Bloomington Plan Commission
FINAL STAFF REPORT

Case No 70/DP-73-83

Location Southwest corner of 14th and Dunn

January 9, 1983
Staff Report - Site Plan Review
ZO/DP-73-83
Farnes, Carrithers, Baldwin & Burks

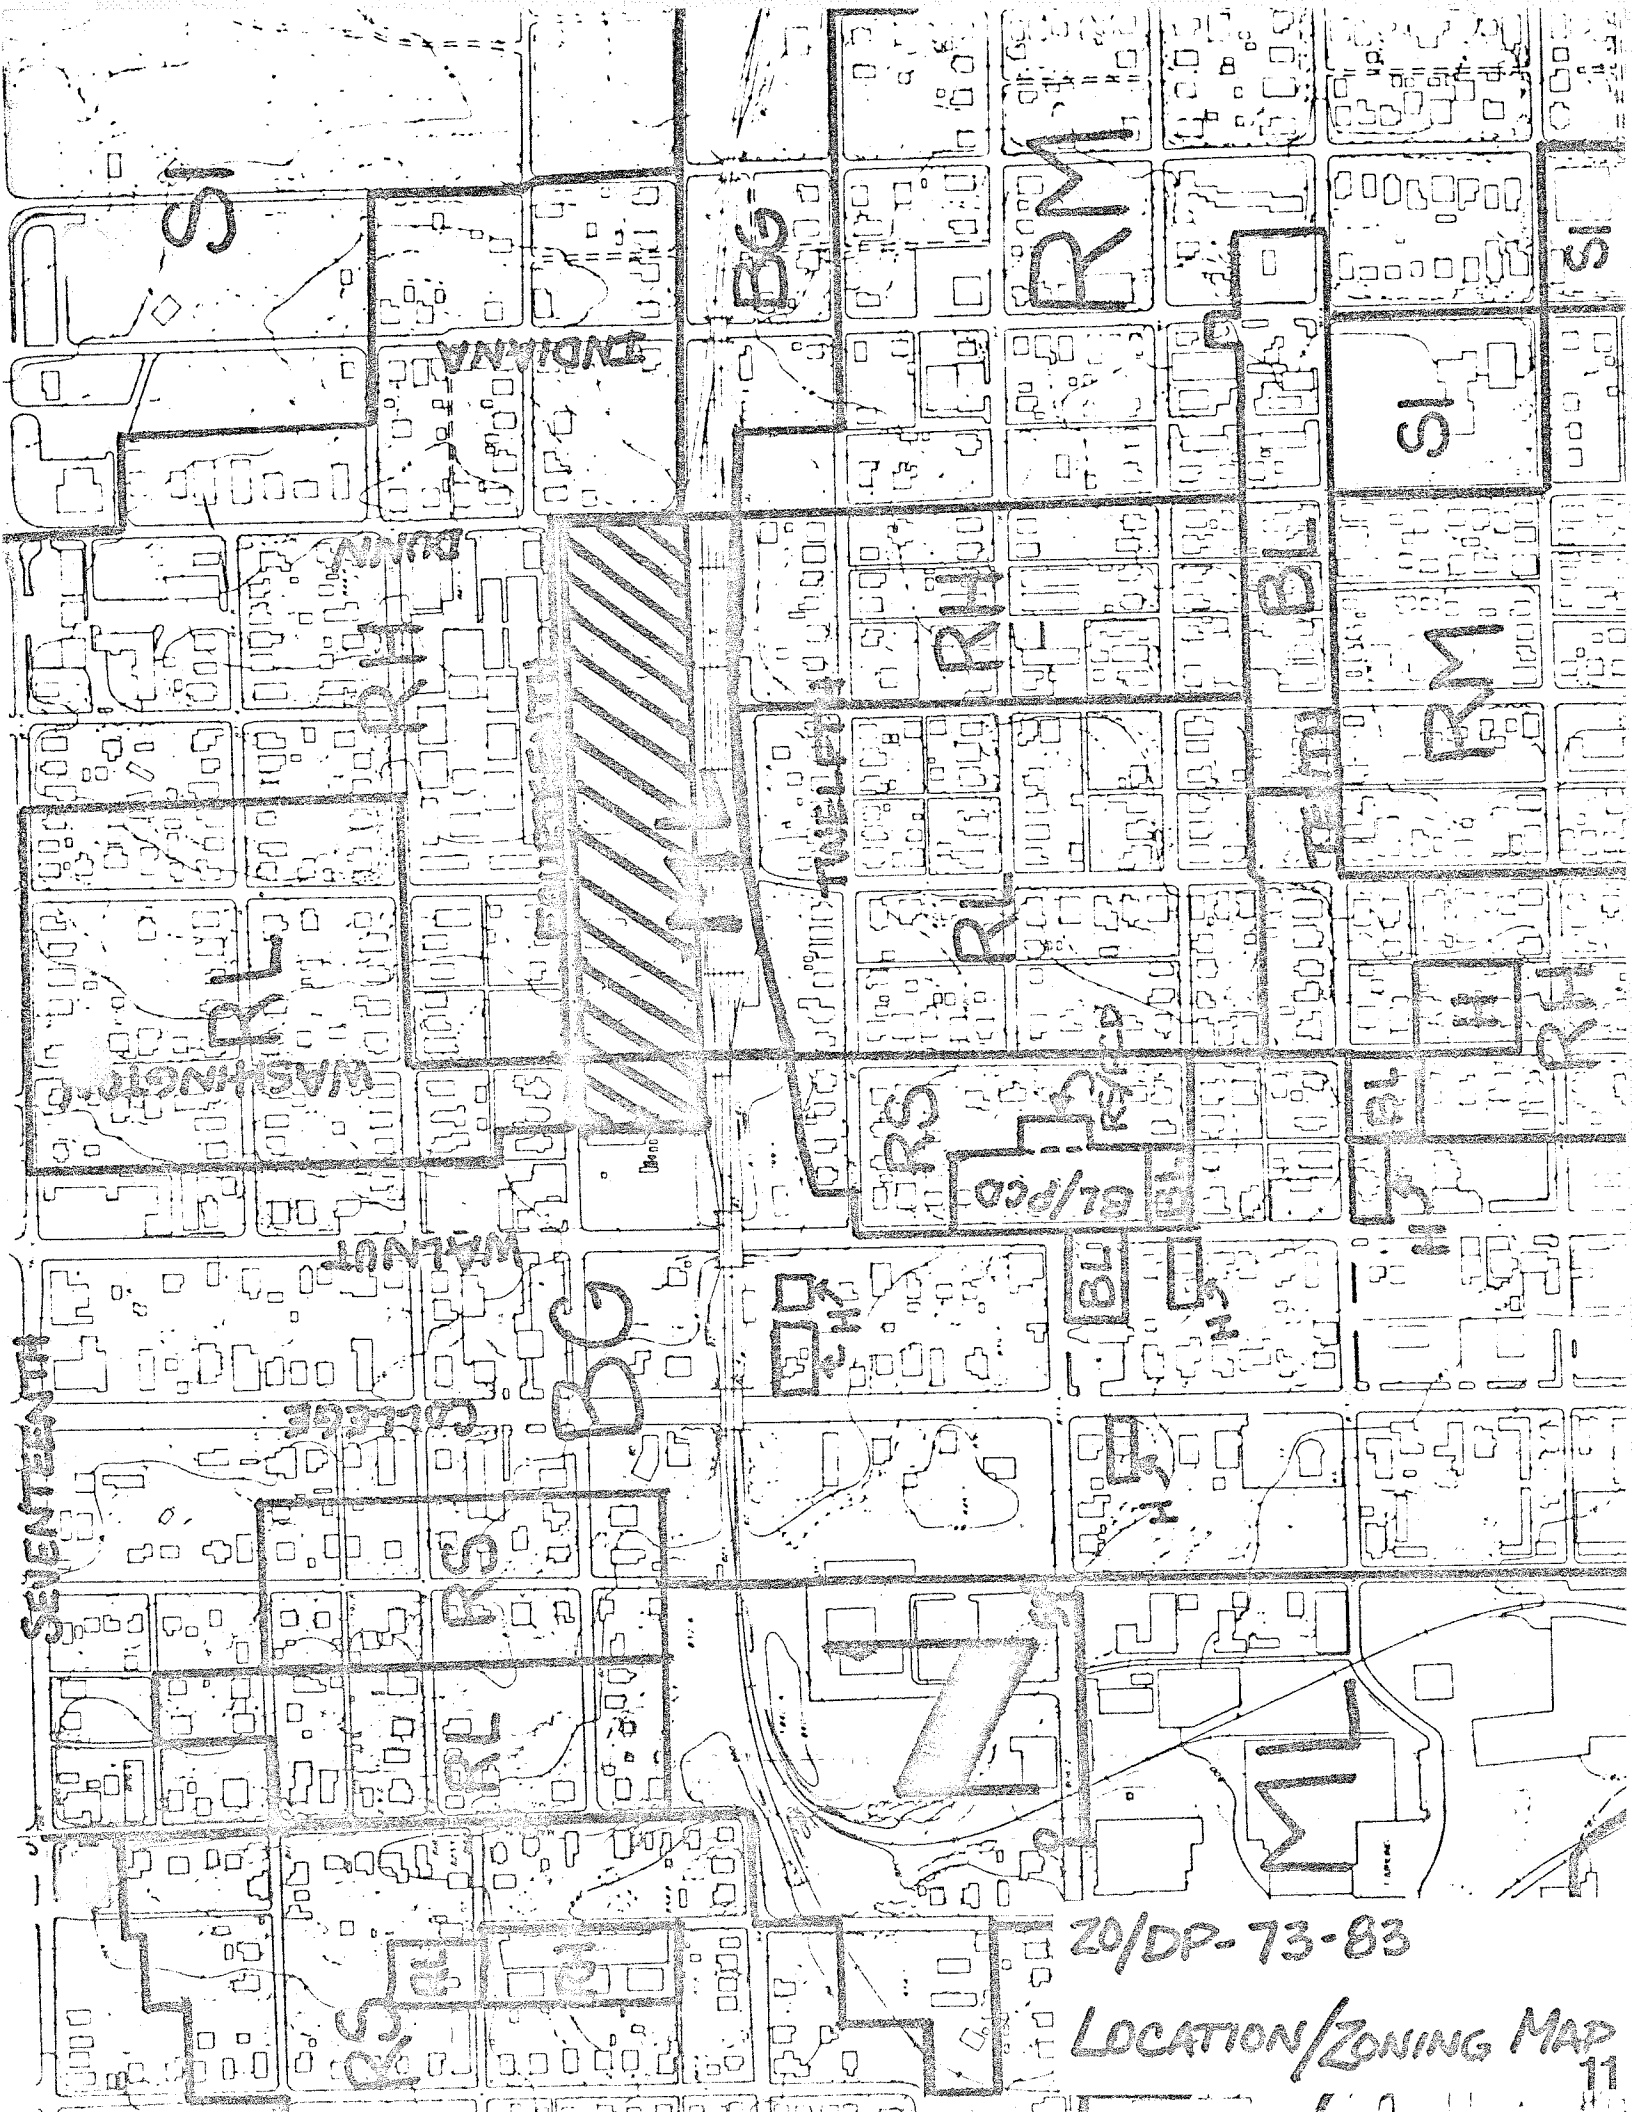
The staff has reviewed the first draft submittal of the site plan and finds that the plan conforms with applicable dimensional and parking requirements. Detailed grading, landscaping, and drainage details have just been submitted and are being reviewed. Pending completion of these reviews, staff will make recommendation, if possible, at the the hearing.

In general, the plan makes good use of a site having a shape which limits what can be done. All access is from 14th, avoiding the awkward Dunn Street intersection. Parking and its access are located on the interior of the site, surrounded by buildings, which should improve the project's looks, from surrounding properties. The buildings are stepped to fit the grades, a design element which improves the appearance and minimizes massiveness of the buildings.

The rather complete lot coverage and grading result in retention of only a few of the existing trees. The developer proposes to utilize a tree spade to relocate all sound specimens on the site up to a size of 6" - 8" caliper.

Storm water will be detained in 3 basins, one in the 14th Street front setback, one at the tracks, and one in the Dunn Street setback. Computations and specific design are being reviewed.

If staff completes its review and finds no problems, we will recommend approval, contingent upon council passage of the rezoning, and with the stipulation that the Commission reserves the right to add any new conditions which may result from the council's zoning consideration.
